HEARING 17 - Sweep up, Interpretation etc.
STATEMENT BY SUBMITTERS VISION KERIKERI, OUR KERIKERI TRUST,
CARBON NEUTRAL NZ TRUST AND KAPIRO CONSERVATION TRUST

“Infrastructure-ready” statements

Figure 1: Beca (2024) forecast average daily flow (ADF) - inflow to WWTP

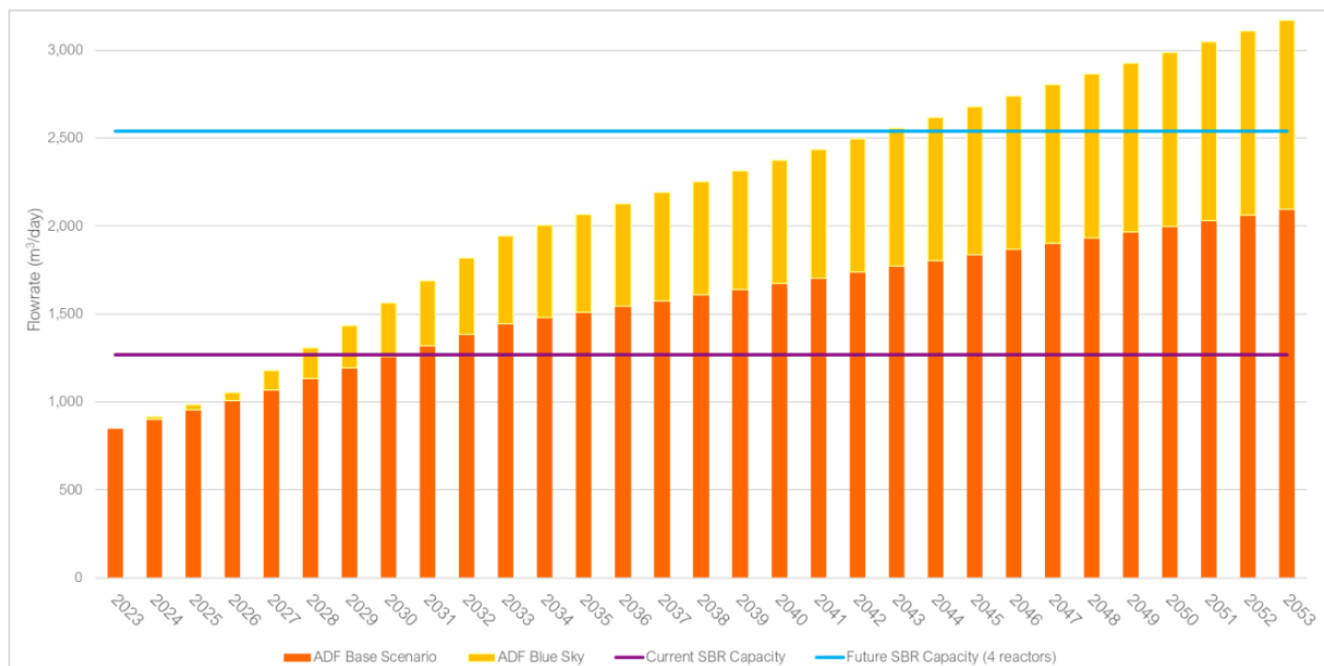
We consider that Beca's 2024 assessment for the Spatial Plan scenario over-estimates the current capacity of the WWTP. Beca's estimates that the average daily inflow to the WWTP will reach the SBR capacity in the year 2028 – reproduced in Figure 1 below.¹⁹

Beca has therefore recommended expansion of two additional reactors and several other upgrades in the "medium term".²⁰ Our analysis indicates the expansion is needed sooner.

Beca estimates a cost of expansion between \$9 million and \$20 million in the “medium-term” (reproduced in Table 3, below).²³ However, Beca’s forecast inflows to the WWTP indicate that expansion will need to be implemented by 2028 (Figure 1 above), or possibly earlier (Figure 12 in Beca report 2024, p.51).

As noted above, Beca estimates that the average daily inflow to the WWTP will reach the SBR capacity in the year 2028. However, the treatment capacity of the Kerikeri wastewater treatment plant (WWTP) has been and continues to be exceeded on some days, even during normal rainfall. We calculate that additional capacity is needed urgently.
